Canterbury Bankstown Council Submission Exhibition of SSD-9831 (WSU Bankstown City Campus)

CANTERBURY BANKSTOWN COUNCIL'S SUBMISSION

Issues in response to the State Significant Development Application SSD-9831

74 Rickard Road and part 375 Chapel Road, Bankstown

Maximum Water Depth

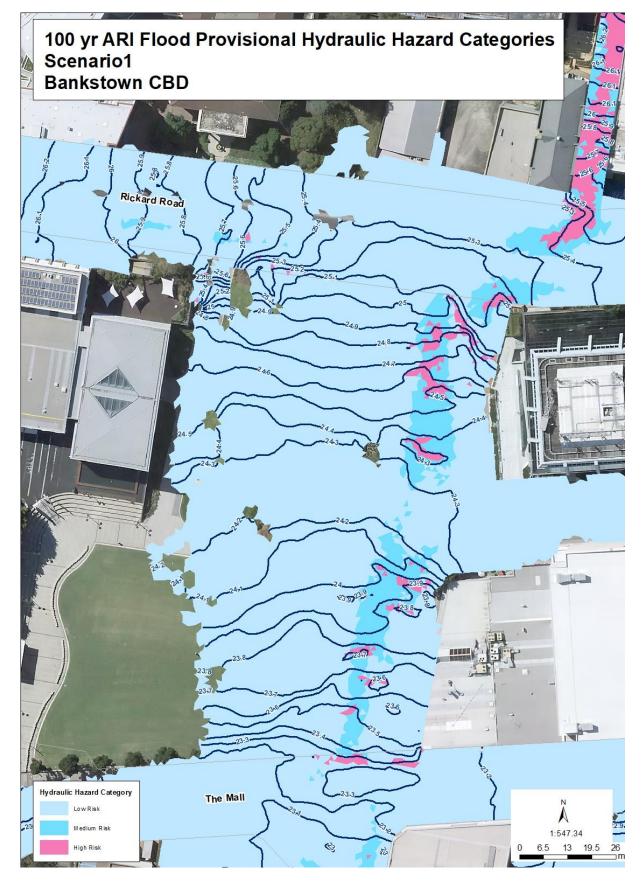
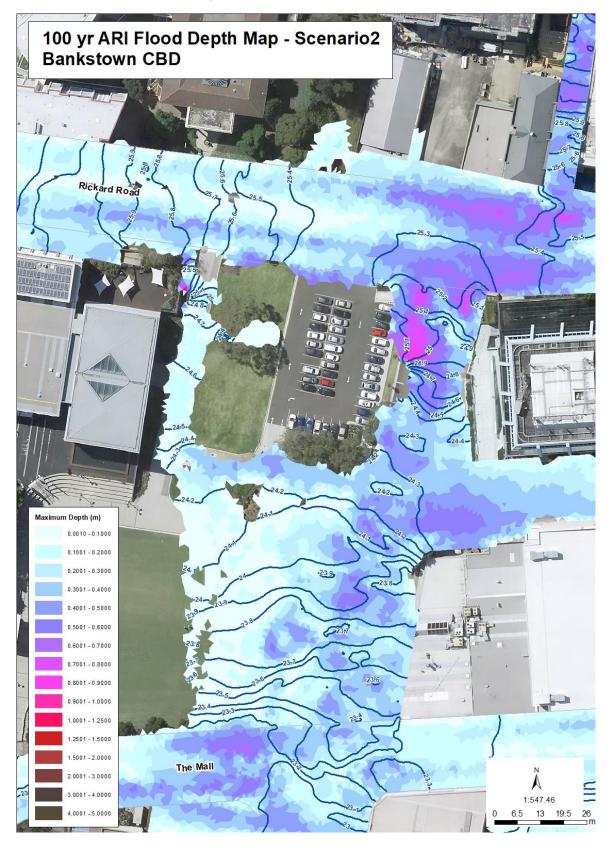
The proposed WSU building results in up to 0.3m higher maximum water depths along Rickard Road near the intersection with The Appian Way and up to 0.59 m in the section of The Appian Way between the new WSU building and the Council administrative building. These locations are marked in red circles in Figure 7. The highest increase of 0.59m is seen approximately half way along the eastern wall of the new WSU building where a part of the structure protrudes into the floodway. This protrusion also appears to have an impact on water depth increase along the western wall of Council's building (up to 0.19m).

Consequently, the hazard category for the section between the new WSU building and the Council administrative building will rise from medium risk to high risk (Figure 8) in the majority of the street section. The maximum velocity-depth product increases from 1.0 to 1.3 at the most affected location at this section.

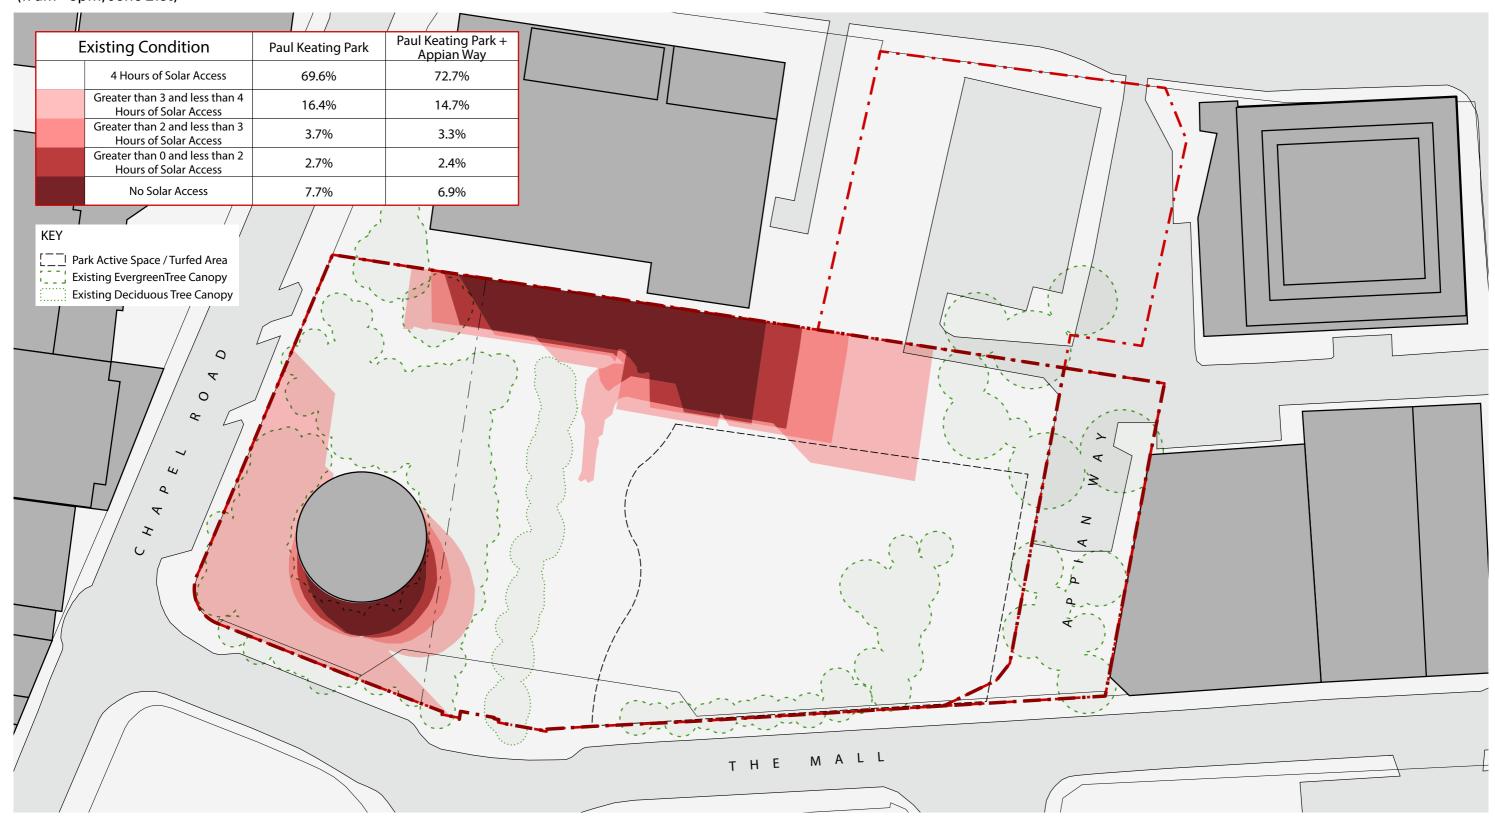
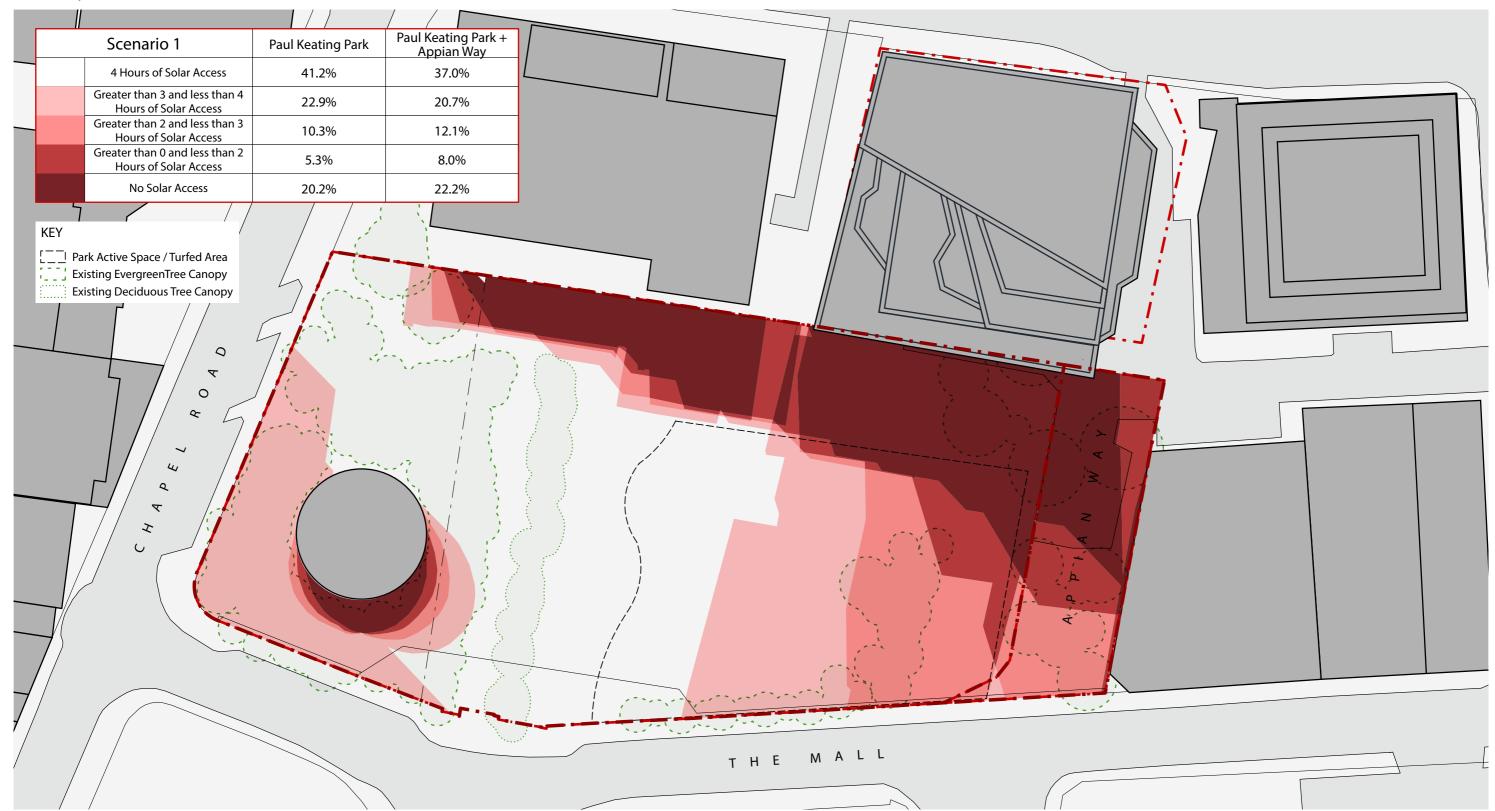
- The WSU proposal creates significant additional overshadowing impact in relation to the existing built form around the Park.
- The WSU proposal creates significant additional overshadowing impact in relation to a complying development on the subject site under BLEP 2015.
- 3. In Scenario 1, 41% of the Paul Keating Park area receives 4 hours of continuous sunlight on the Winter Solstice. The majority of this area is on the hard-stand where the Council Chambers is located, and is already overshadowed by existing surrounding trees (evergreen and deciduous).
- 4. 70% of the existing grass turf area of the Park would be impacted by the overshadowing from the WSU proposal.
